Environmental Impact Report

EQD No. 81-1212
SCH No. 82010619

SUBJECT: North City West Neighborhoods 4, 5 and 6. PRECISE PLAN, COMMUNITY PLAN AMENDMENT, PLANNED DISTRICT ORDINANCE AMENDMENT and three TENTATIVE SUBDIVISION MAPS to develop 4,098 dwelling units, one neighborhood commercial center, one visitor commercial center, a 34-acre employment center, two elementary schools/neighborhood park complexes and open space areas on approximately 840 acres. Located on the north side of Carmel Valley Road between El Camino Real and Black Mountain Road in the North City West community (Portions of Sections 17, 19 and 20, T14S, R3W). Applicant: The Baldwin Company

Figure 24

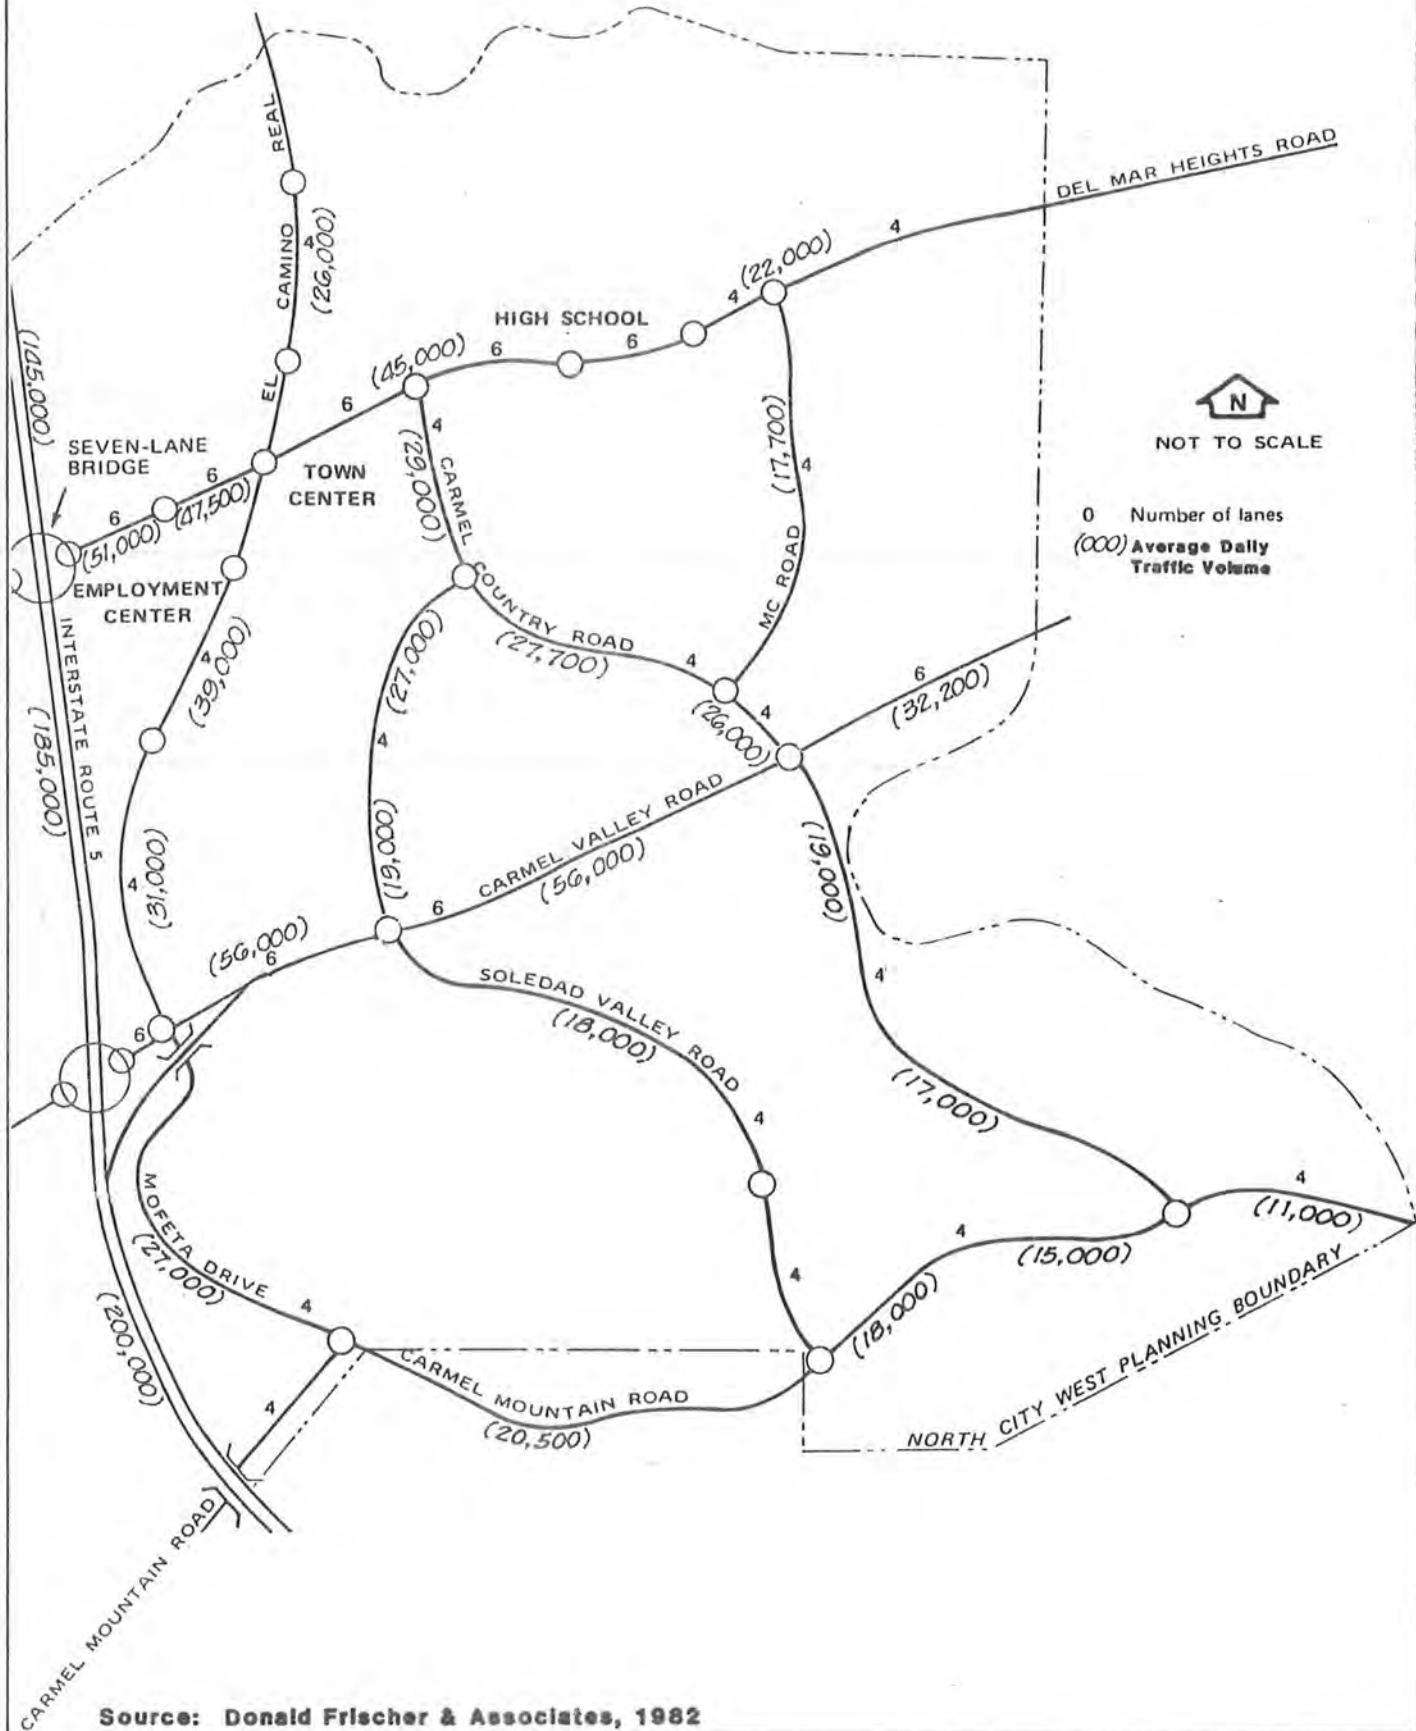
- 31** 1. One of the stated conclusions is that potentially significant traffic impacts can be mitigated to a level of insignificance. That conclusion, however, applies mainly to traffic within the proposed development. Figure 24 shows average daily traffic of 185,000 and 200,000 on Interstate 5. As pointed out in Caltrans comments of July 8, 1982, on the Baldwin Precise Plan, the congestion threshold of Interstate Route 5 in the vicinity of Del Mar Heights Road is around 130,000 ADT. Caltrans has no present plans to increase freeway capacity in that vicinity and does not have funds to carry out the regional improvements listed in Table 9.
- 32** 2. Page 117 states that Park-N-Ride facilities will be financed through the facilities benefit assessment mechanism. If fee ownership can be transferred to the State of California, Caltrans can participate by maintaining and operating the sites.

- 31** The I-5 volumes shown on Figure 24 (EIR, page 105) are identical to the volumes shown in the City's adopted I-15/North City Travel Forecast. Implementation of the precise plan would not cause trips to be generated onto I-5 beyond those which have already been projected and approved by the City of San Diego.
- 32** The North City West Public Facilities Financing Plan (page 50) notes that Caltrans may participate in maintaining and operating the park-and-ride facilities.
